**The Meadows at Bailey Canyon Specific Plan  
Environmental Impact Report**

**City of Sierra Madre**

**DUDEK**

**JANUARY 2022**

Map from the Specific plan

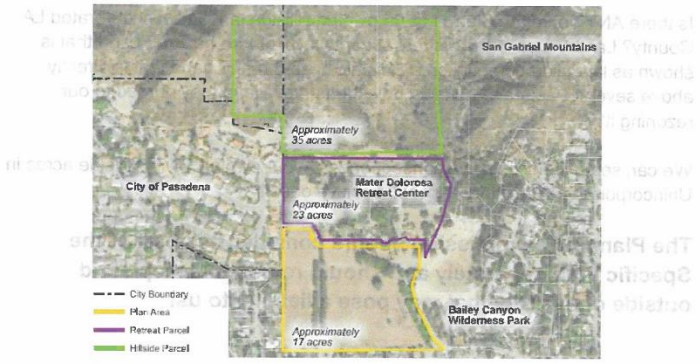
The 2 remaining parcels which they are now able to donate include  
APN: 5761-001-001 in Sierra Madre - 20 acres, designated Hillside Zone AND  
APN: 5760-027-013 in Unincorporated LA County - 16.74 acres zoned residential  
Maps are attached showing those parcels.

Is there ANY benefit to Sierra Madre owning Hillside land in Unincorporated LA County? Land that is in the highest severity level of Fire hazard? Land that is shown as landslide potential on a Seismic hazard map? Land that is directly above several Pasadena housing developments? Have they agreed to our rezoning it??

**The Planning Commission should consider this part of the Specific Plan separately and should refuse to accept land outside of our City that may pose a liability to us!**

- I2-11** The comment provides background information associated with the open space hillside conservation easement area and information contained in the Specific Plan and does not raise an issue related to the adequacy of any specific section or analysis of the Draft EIR. It should be noted that Figure 1-2, Vicinity Map, from the Specific Plan has been revised for clarification, in order to show the most recent boundaries of the proposed 35-acre open space hillside conservation easement area. No further response is required or provided.

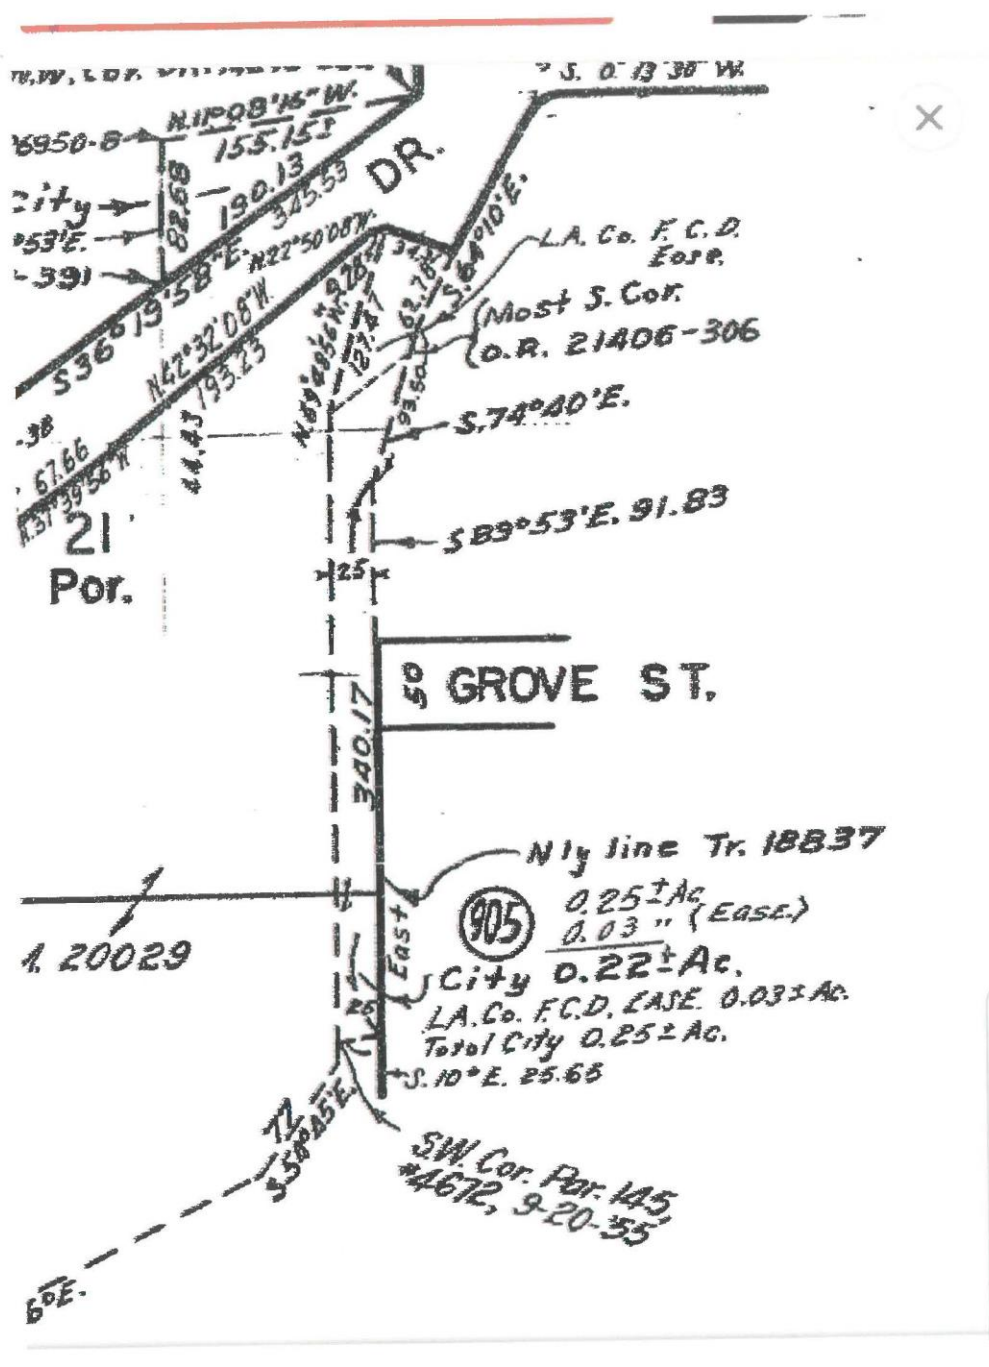
**D. WHY IS THERE NO DIRECT ACCESS TO MICHILINDA SO TRAFFIC CAN LEAVE THE MONASTERYH AND NOT IMPACT THE REST OF THE STREETS IN THIS NW QUADRANT OF THE CITY.**

**1. THERE ARE 2 FIRE ACCESS ROADS THAT END ON THE SMALL STREETS ADJACENT TO MICHILINDA**

**2. WHY NOT IMPROVE BOTH OF THEM TO LET THE TRAFFIC OUT ONTO MICHILINDA, A STREET ALREADY DESIGNED FOR A GREAT DEAL OF TRAFFIC.**

Comment Letter 169

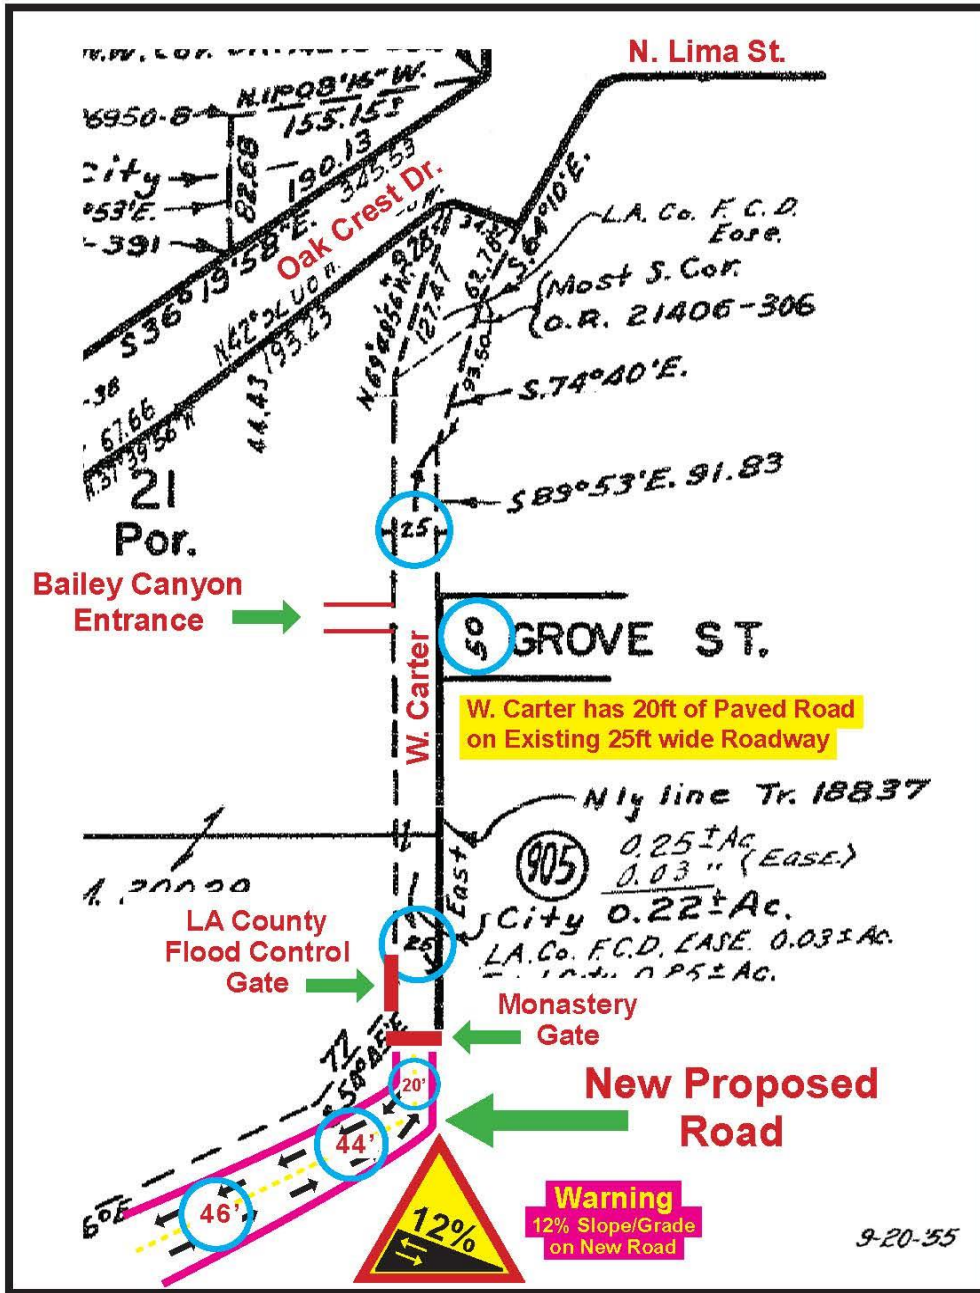
**From:** Nancy Beckham <nbeckham48@gmail.com>  
**Sent:** Monday, October 4, 2021 2:19 PM  
**To:** Jose Reynoso; Vincent Gonzalez  
**Subject:** The upgraded letter regarding Carter and the DEIR, the Urban West map, the Final Plate Map  
**Attachments:** Letter regarding DEIR and Carter.docx; Map streets and pads.jpg; Final Plate Map W. Carter rev 10.01.2021-4 copy.pdf

- I69-2** This comment provides a map of the project site. Although not specified, this map closely resembles Draft EIR Figure 3-10, Grading Plan. No discussion was included as part of this comment. However, a similar comment letter prepared by the commenter included the same attachment. Please see Response to Comment I47.

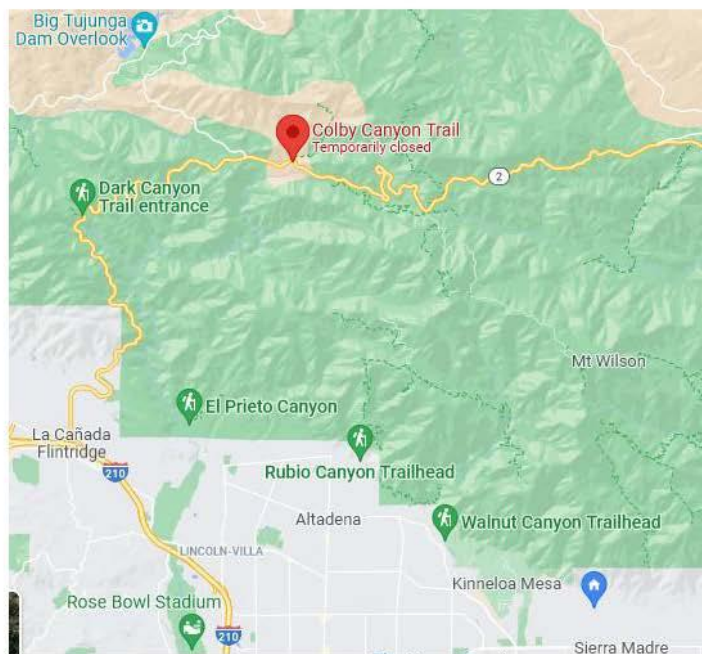
If 3.04 acres of the 3.39 acres is the park, then that leaves .35 acres of open space. Under Project Location above, the area is identified as 35 acres. In project objective number 5, 30 acres is referenced and the area is clearly misidentified as being near Colby Canyon and Colby Canyon Trail. (see Objective 5. Preserve the hillside open space area by dedicating approximately 30 acres north of the Mater Dolorosa Retreat Center to the City, in order to preserve a portion of Colby Canyon and the Colby Canyon Trail, which would be used by wildlife for movement up and down slope; preserve native vegetation communities and drainages; and preserve land adjacent to the Colby Canyon stream). Colby Canyon is above the city of La Canada nowhere near this project. See map below. Thus, the location, boundaries, and acreage of the “open space” are not clear.

- 189-45** This comment requests clarification on the open space areas within the project. Specifically, the commenter asks where the remaining 0.35 acres of open space would be located on the project site. As discussed in Draft EIR Section 3.3.2, Neighborhood Park and Open Space, the development of an approximately 3.04-acre neighborhood public park at the southernmost portion of the project site as well as development of approximately 0.35 acres of passive open space located to the east of North Sunnyside Avenue and west of Carter Avenue, adjacent to Streets A and B (Please refer to Figure 3-2, Conceptual Site Plan). This comment also states that the name Colby Canyon is incorrectly used. Please refer to Response to Comment I42-26. In addition, Draft EIR Figure 3-4 shows the approximately 35 acres of open space hillside land to be conserved, located north of the existing Mater Dolorosa Retreat Center. Lastly, Final EIR Chapter 3 includes a few additional clarifications related to the project description, including a few errors correcting the open space deduction from 30 acres to 35 acres. These revisions do not raise new or additional environmental issues concerning the adequacy of the Draft EIR.

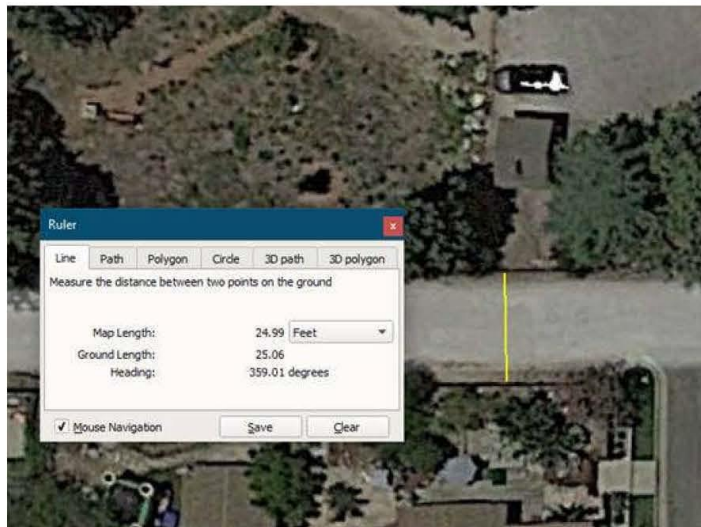
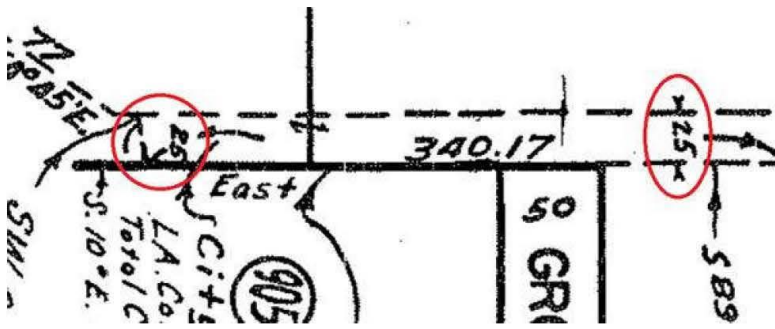
Vincent, there is an inconsistency between the Meadows draft EIR and the Specific Plan.

The right-of-way section of Carter that the city owns south of Bailey Canyon Park is listed as being 20' wide in the Specific Plan (page 20) and 25' wide in the dEIR.

FIGURE 3-4  
Open Space Conservation Easement  
The Meadows at Bailey Canyon EIR

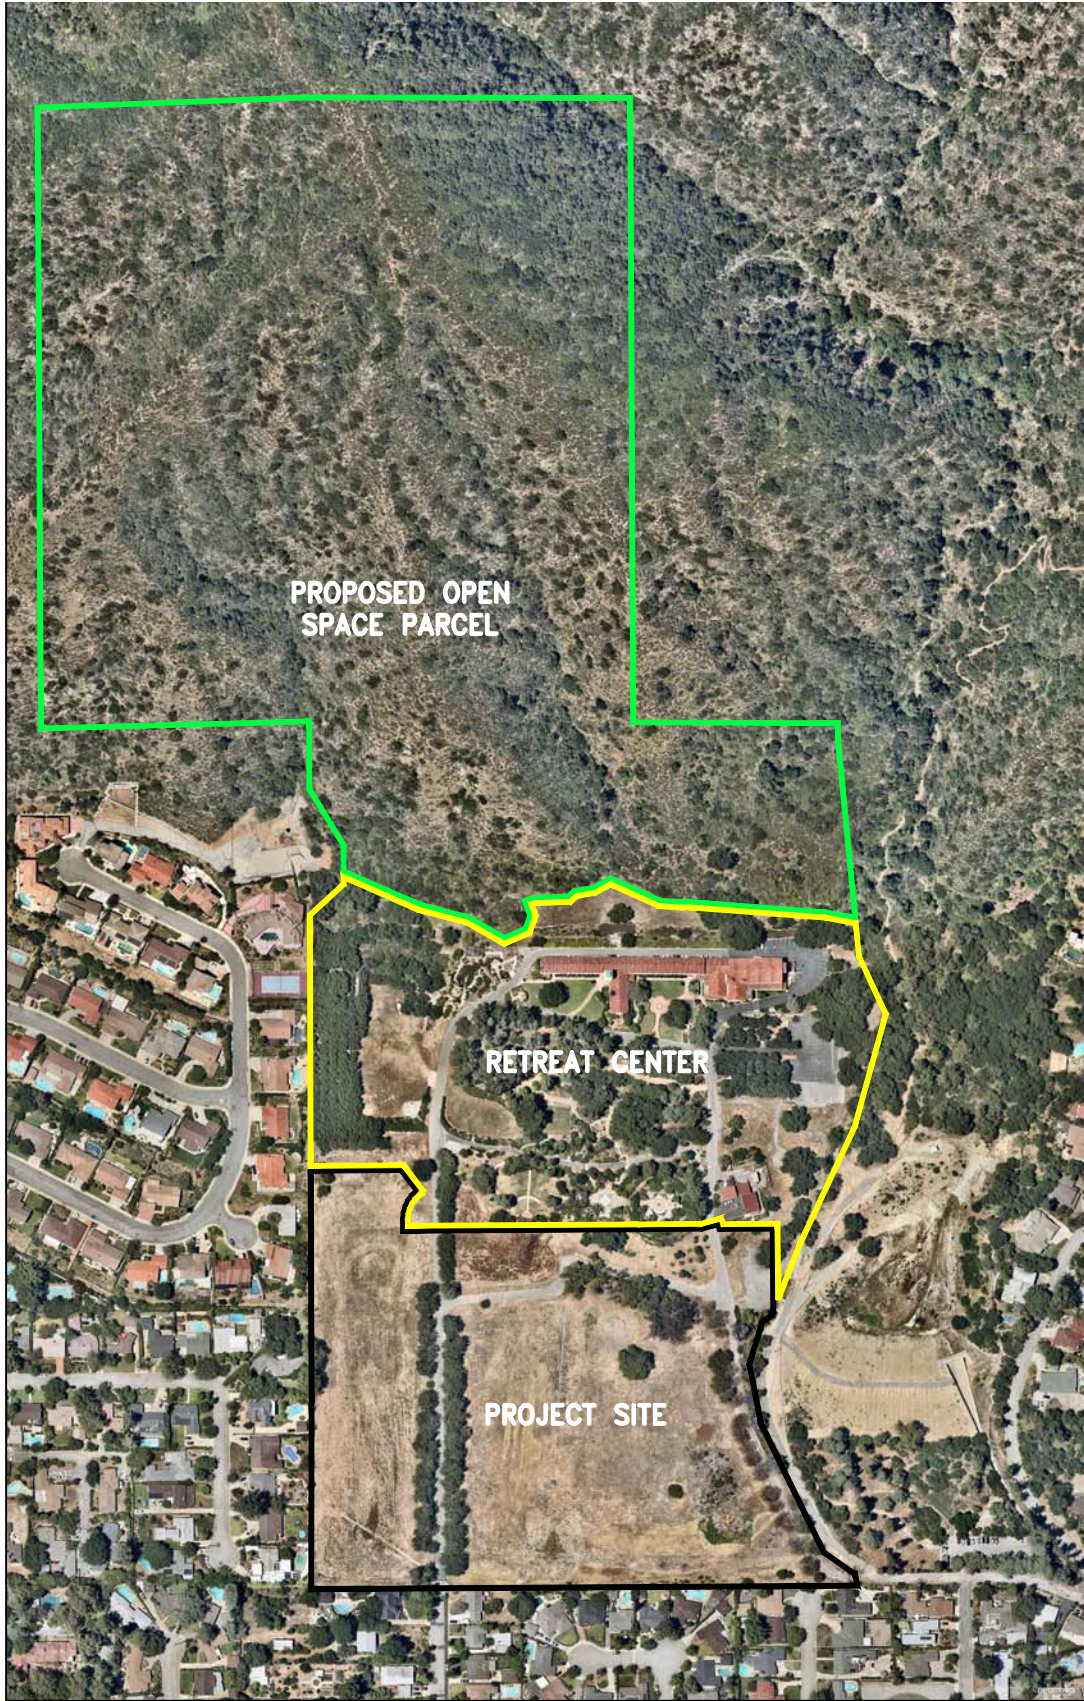
Figure 1-2, page 5 the hillside parcel called out for donation in the Meadows Specific Plan, included an area that is a portion of an Open Space parcel already owned by the city: APN 5761-001-900. The project map shows a 20-acre portion as a donation of city owned open space which is not the Monasteries to donate.

In the Draft EIR, Figure 3-4, Proposed Open Space Dedicated area, there is a different plot outlined which appears to have corrected this. The total donation proposed would have to be updated. It is unclear what acreage is being considered for donation.

The comment cites Figure 1-2 of the Specific Plan and states Figure 3-4, Proposed Open Space Conservation Easement Area, of the Draft EIR appears to be different from the Specific Plan. As described in Draft EIR Chapter 3, Project Description, the project proposes approximately 35 acres of open space hillside land to be preserved. Conveyance of the open space hillside land to the City would be effectuated through execution of a development agreement between the City and the project applicant/landowner. It should be noted that Figure 1-2, Vicinity Map, from the Specific Plan has been revised for clarification, in order to show the most recent boundaries of the proposed 35-acre open space hillside conservation easement area.

- 189-44** The comment states that the open space has not been defined, asks what the benefit is to the community, and asks if open space would be available to the public. The open space has been defined in Figure 3-4 of the Draft EIR. Project Objective 5 describes the benefits of the open space easement, which include in preservation of a portion of Bailey Canyon and the Bailey Canyon Trail, which would be used by wildlife for movement up and down slope; preservation of native vegetation communities and drainages; and preservation of land adjacent to the Bailey Canyon stream (see Final EIR Section 3.2, Project Objectives). This open space area would not be open to the public. Also, please refer to response I85-6 which discusses that, because no development is proposed in this area, and because the area would be conserved in perpetuity, comprehensive environmental review of the open space conservation easement is not required.
